AMENDMENT TO THE DRAWINGS

Appl.No. 09/775,568
Amdt. Dated Sep. 10, 2004
Reply to Office action of Aug. 13, 2004
Replacement Sheet

Fig.9

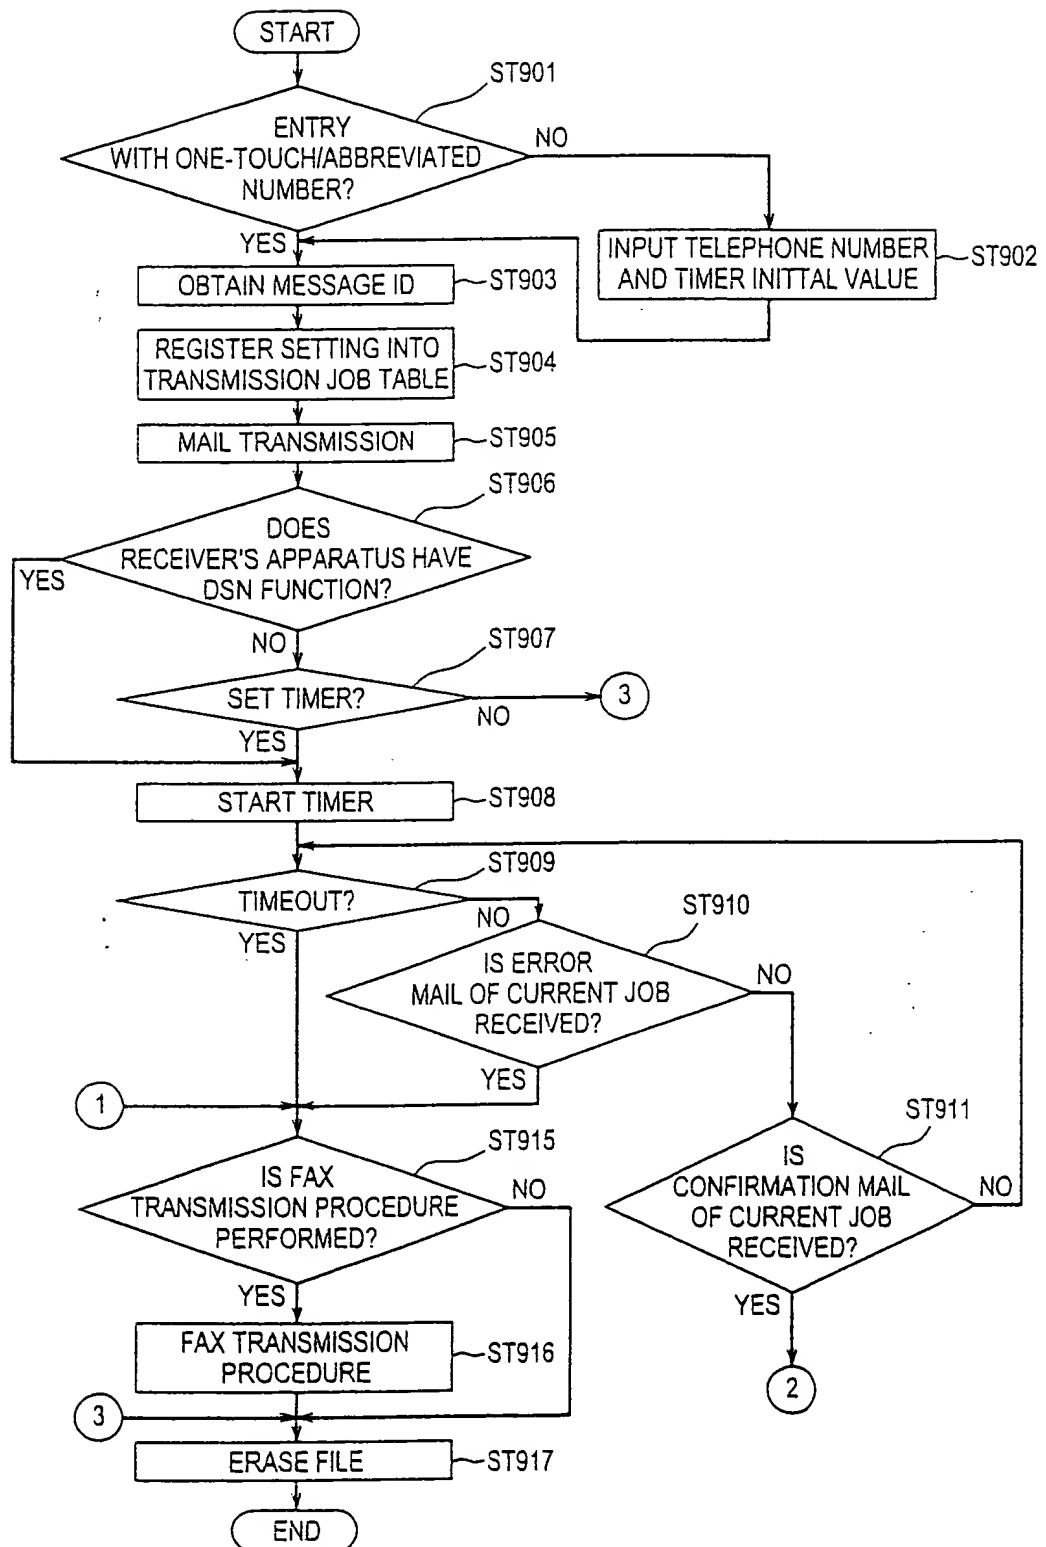
Fig.9 has been amended to remove the second term "IS" of ST 901.
